## Staff Report

To: BOZAR  
From: Jessie Earley, Senior Planner  
Meeting Date: DRC, February 17, 2026 (Tuesday)  
RE: 5 Seventh Street (Roberts), Preliminary Review

### **PROJECT TITLE:** Roberts (5 Seventh Street)

**SUMMARY:** Consideration of the application of **Morgan Harcrow Roberts** to site additions to the existing single-family residence and accessory building located at 5 Seventh Street, South ½ of Lots 1, 2, and 3 and the East 5 feet of the South ½ of Lot 4, Block 53, in the R4 zone. (Hadley)

**Proposed Streetscape**

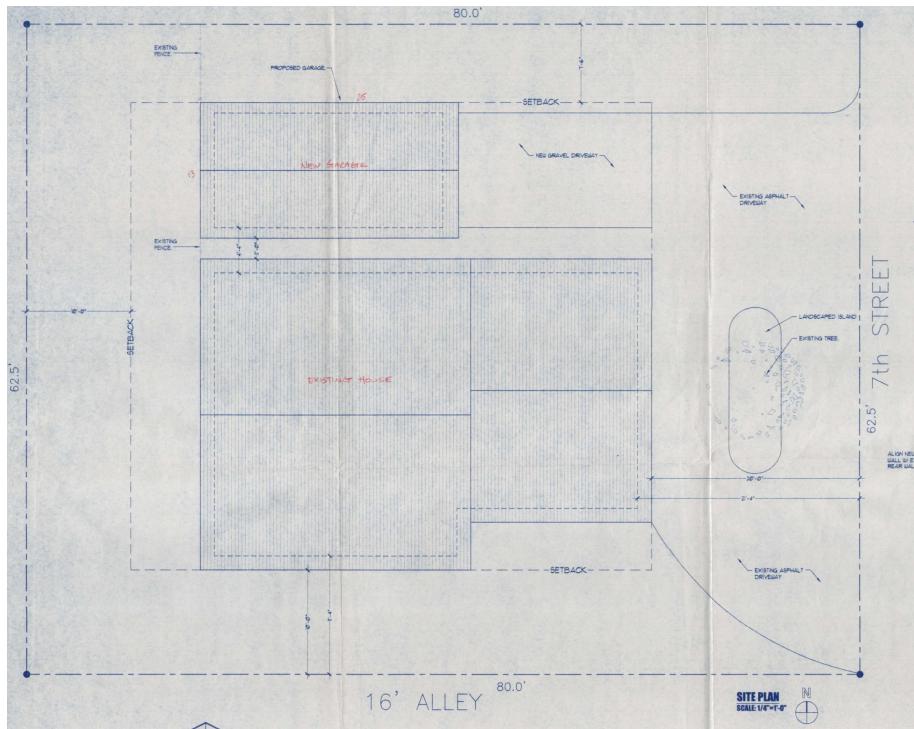
**Context:** Refer to guidelines 4.25-4.26. The neighborhood contains a mix of small 1 ½ story and two-story homes. The roof forms are relatively simple. Consider whether the forms and style of the additions will relate with the existing forms found within context and style of the neighborhood or if they will appear excessively dissimilar.

The Board should determine whether the overall scale and forms of the residence comply with the intents 4.25 and 4.26 (excessively similar or dissimilar) in relation to the neighborhood context.

**Existing Site Plan**

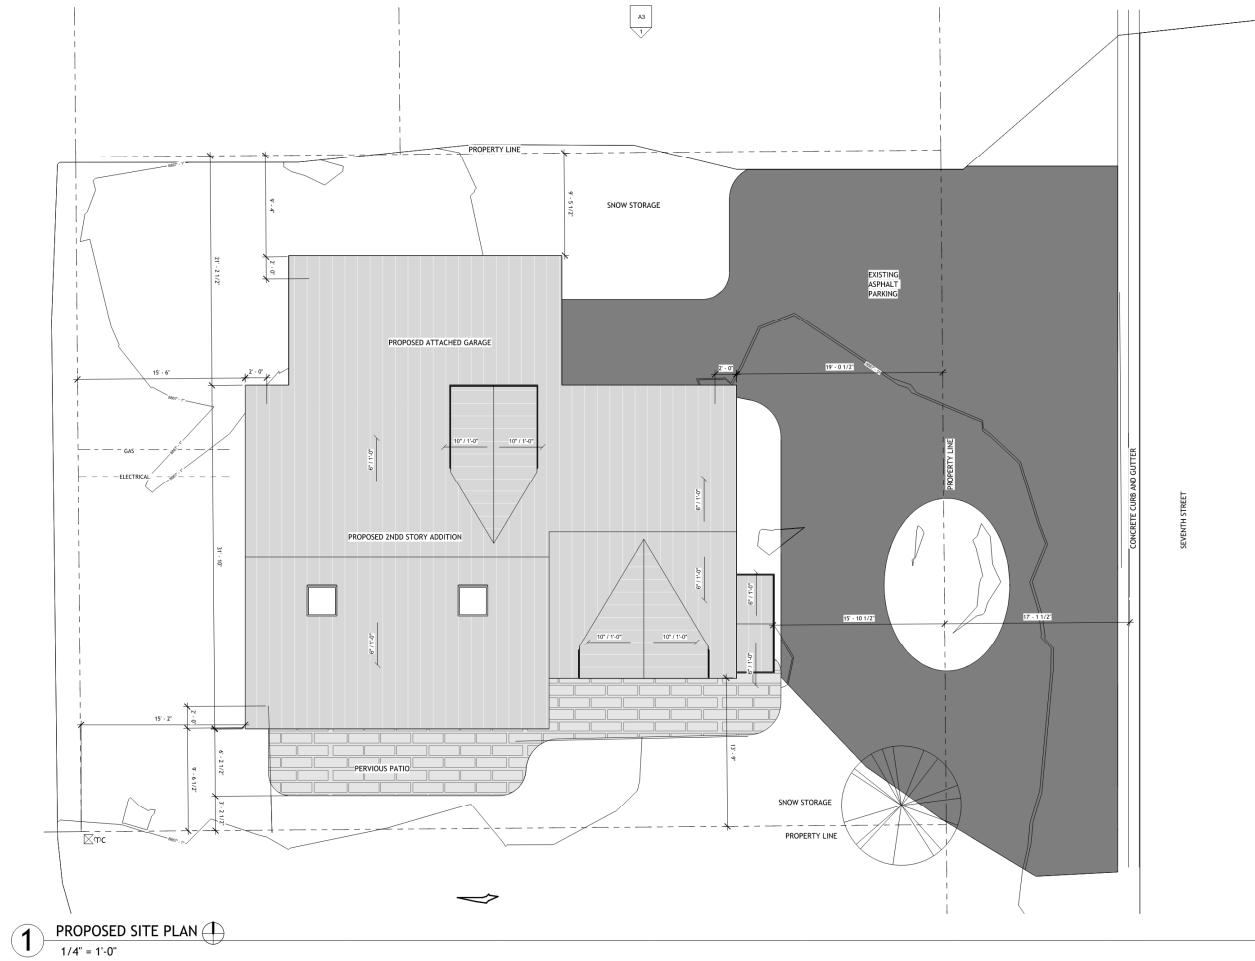
Width	NA	27'4" (existing) 39'9" (proposed)	Yes
Snow Storage	>33%	31%	No, clarify areas
Parking	2 spaces	--	None shown

A demolition plan is needed to confirm that the areas of demolition are less than 25% ,as required in Section 16-14-190 (5) a.

## Proposed site plan

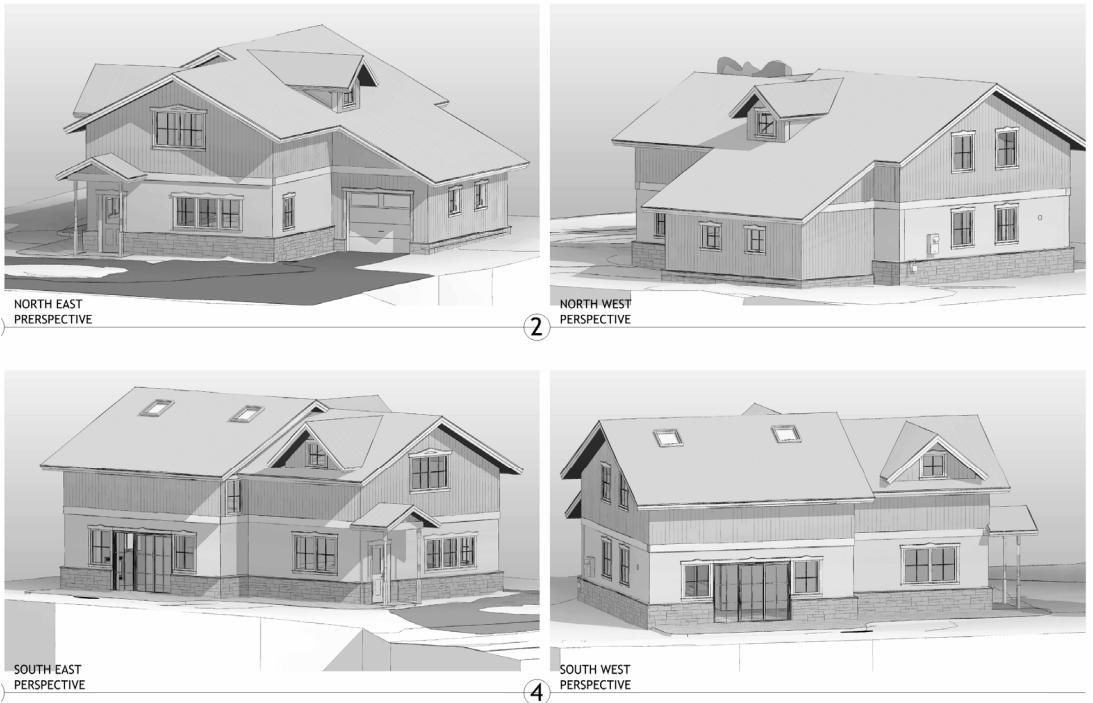
GL	Staff Analysis	DRC Recommendation
Topography	Topography lines have been included. The bulk of the lot is 8867'1". The elevations note average grade as 8867'6", which is not correct per the site plan. 8867'1" would be the value used for measuring FAR.

2.8 Drainage	Drainage information has not been provided, but must be.	
Easements	None noted.	
2.16 Substantial landscaping	The plan is fairly minimal. Provision of a final landscape plan will be required for review and approval if revisions are proposed after permitting prior to a CO.

2.18 Preservation of existing trees	The site plan must include information about the existing trees on the site that will be maintained. One tree is shown on the site plan on the southeast corner. In the photos, there appears to be a tree on both the northeast and southeast corner.

2.19 New trees	Clarification about existing versus proposed trees which meets the intents of GL 2.19 a.	
2.16 a/ 2.20 Native plantings	Ground cover has not been noted and is encouraged to be native grasses by the GL.

(2.37-2.40)/ 16-17-40 Exterior Lighting	Exterior lighting has not been called out, but must be to ensure compliance with the night sky ordinance. Any existing exterior fixtures must be replaced if they do not meet current standards as well.	
Solar 2.10	NA	
Utilities	Utility lines for wastewater, water, electric and gas have not been noted on the existing plan, but must be.  Adjacent rights of way must be included to scale, which include Seventh Street

and the alley.	
2.7 Snow Storage	Snow storage has been provided onsite, but does not appear to meet the 33% requirement of the areas to be plowed. These areas should be delineated to ensure the proper amount has been allocated.	
2.25 Fences	NA

*Proposed – First floor plan*

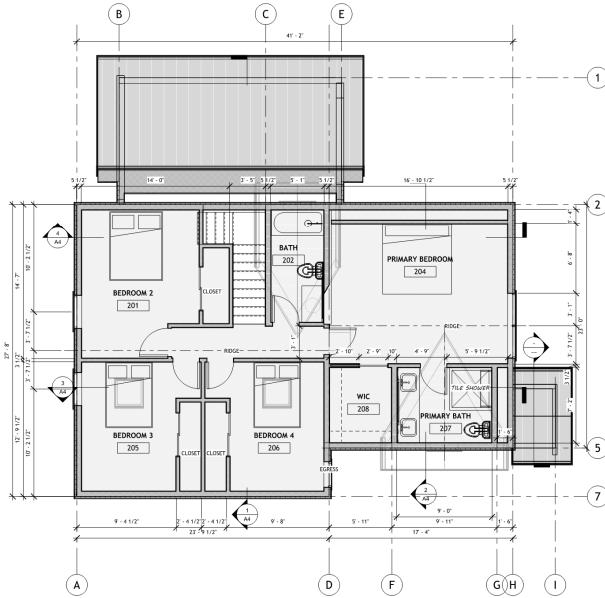
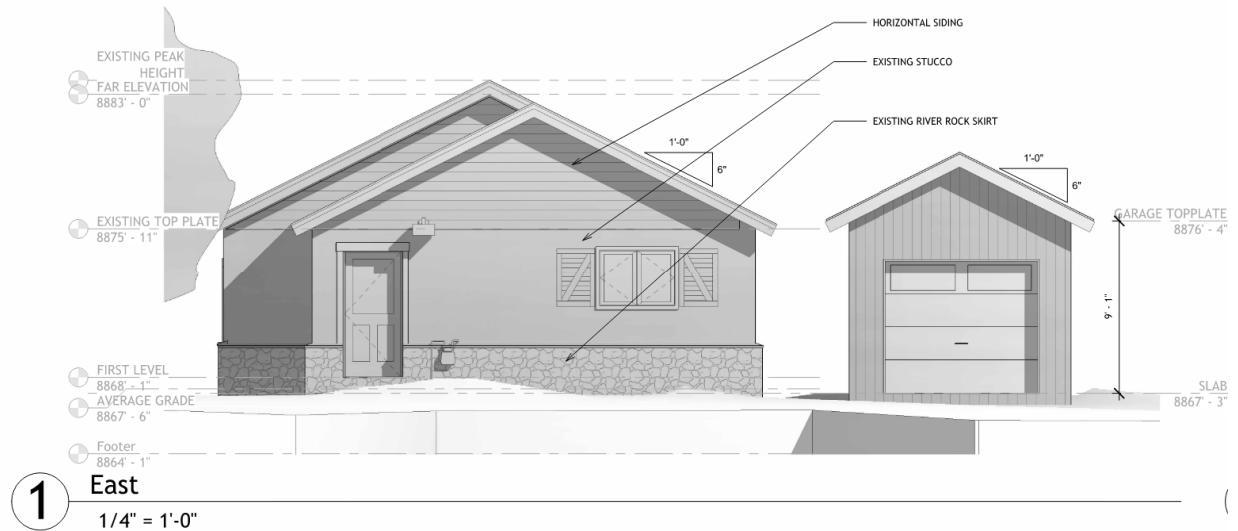
The addition will propose to remove the roof from the existing building and increase the height of the main gable module to 22'5". Then, the secondary gable will have a height of 21'3". Then, in an effort to attach the garage to the primary building, there is a shed roof to the north. There are two gable dormers proposed for each of the sides (north/south). The proposed roof pitches are 6:12 for primary roofs with 10:12 roofs for the dormers.

GL	Staff Analysis	DRC Recommendation
4.32 Scale	This addition relates to the overall scale of the neighborhood. Support	
4.33 Diversity of form	<p>The main roof form for the addition will continue the 6:12 pitch of the existing roof form, which appears to comply. Support</p> <p>However, the extension of the roof to the north appears dissimilar and a break in the pitches is encouraged to prevent an asymmetrical roof.</p>	
4.34 Massing	<p>The proposed addition is rectangular as required in the GL. Support.</p> <p>The primary module would be the secondary module, as noted, which is supported by GL 4.34 b.</p> <p>As stated above and in GL 4.34 e, the subordinate module of the garage should be offset with its roof to prevent an asymmetrical roof.</p>

*Proposed – east elevation (front)*

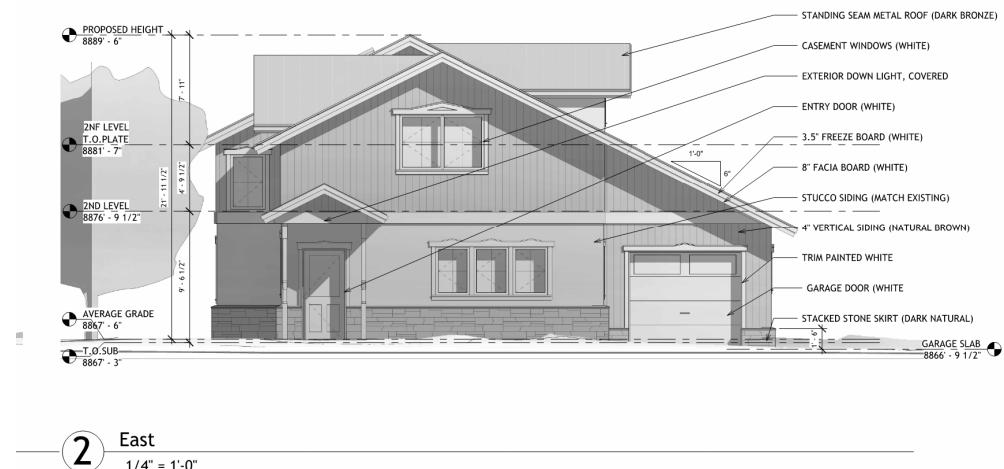
GL	Staff Analysis	DRC Recommendation
4.53 Window to wall ratio	<p>All windows are proposed to be replaced.</p> <p>On the existing east (front) elevation, there is door glazing (6.33 sf) with a two pack of windows on the first floor (11.68). Currently, there is 32.95 (openings)/340.3 sf, which is 9.6%.</p> <p>The proposed east elevation (front) proposes a three pack of windows with door glazing on the first floor (41.6 sf) with a single window and a two pack of windows on the second floor (34.8 sf). The overall window to wall ratio for the proposed is 136.38 sf/ 642.87 sf = 21.2%.</p>

4.58 Groupings of 2 or more windows	There is a grouping of three windows on the east elevation. These windows must have 3.5" of trim and cannot be mulled.

*North elevation dormer*

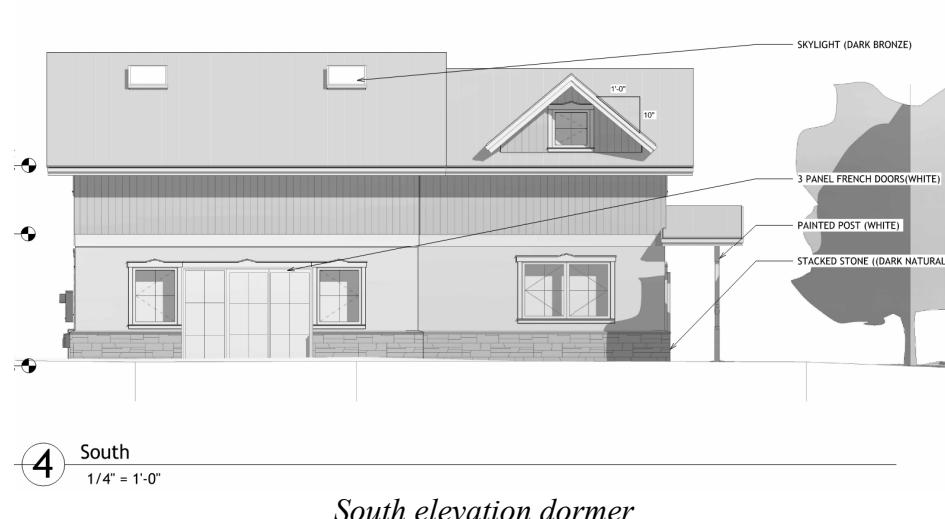
GL	Staff Analysis	DRC Recommendation
4.46 Dormers in new construction	<p><b>South gable:</b> There is a dormer proposed on the south elevation. It is a modified gable dormer. Gable dormers are supported..</p> <p><b>North gable:</b> There is a dormer proposed on the north elevation. It is a gable dormer. Staff finds support.</p>	
4.47 Dormers	<p><b>South gable:</b> The dormer steps down 5" from the ridge of the module.</p> <p><b>North gable:</b> The dormer steps down 8" from the ridge of the module.</p> <p>a. <b>South gable:</b> The dormer, as proposed occupies 28.6% of the roof,</p>

<p>which appears to comply with the GL requirement of 30%.</p> <p><b>North gable:</b> The dormer, as proposed occupies 6.6% of the roof, which appears to comply with the GL requirement of 30%.</p> <p>b. <b>South gable:</b> The dormer is lower than the ridge. There is a section of roof beneath.</p> <p><b>North gable:</b> The dormer is lower than the ridge. There is a section of roof beneath. Discussion is encouraged.</p> <p>c. <b>South gable:</b> The dormer, as proposed occupies 28.6% of the roof, which appears to align with the GL requirement of 30%.</p> <p><b>North gable:</b> The dormer as proposed occupies 6.6% of the roof, which appears to comply with the GL requirement of 30%.</p> <p>d. <b>NA</b></p> <p>e. <b>NA</b></p>

4.48 Skylights	<p>There are two skylights proposed for the south elevation. The measurement appears to be 2'9" x 2'10". The skylights cannot exceed 3'x2". So, they will need to be revised.</p>

*Proposed South elevation*

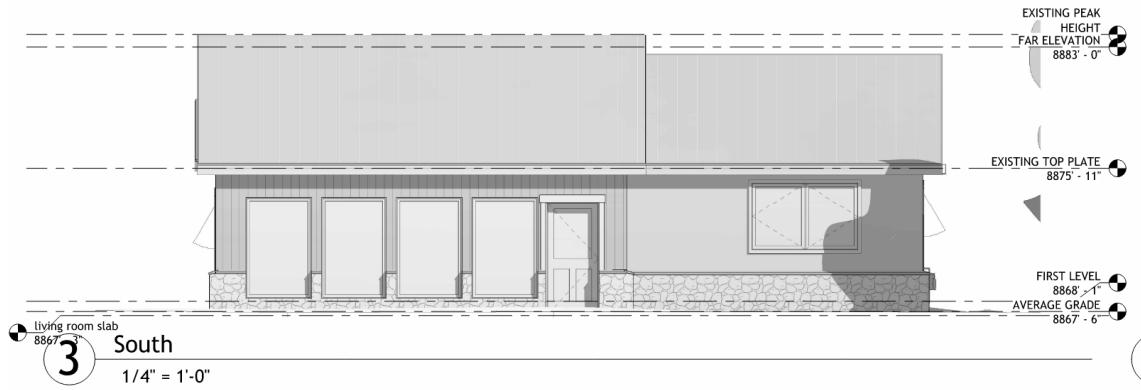
GL	Staff Analysis	DRC Recommendation
4.64/4.65 Primary door	There is a $\frac{1}{2}$ light wood door (white) noted on the east. Support.	
4.66 Secondary doors	<p>There is a three panel folding/French door on the South. This GL allows for one three panel door with a maximum opening of 9' in width in new development zones. This door meets this requirement.</p> <p>This GL also specifies that the door should not be highly visible from the street. This is on an alley side and is in an area of the home that has very large existing openings. Staff finds support.</p>	
2.29 Garage	<p>There is a garage door proposed on the east (front). This normally would be discouraged. However, a garage door exists currently on this elevation. Staff finds support.</p> <p>The door must incorporate a wood veneer.</p>
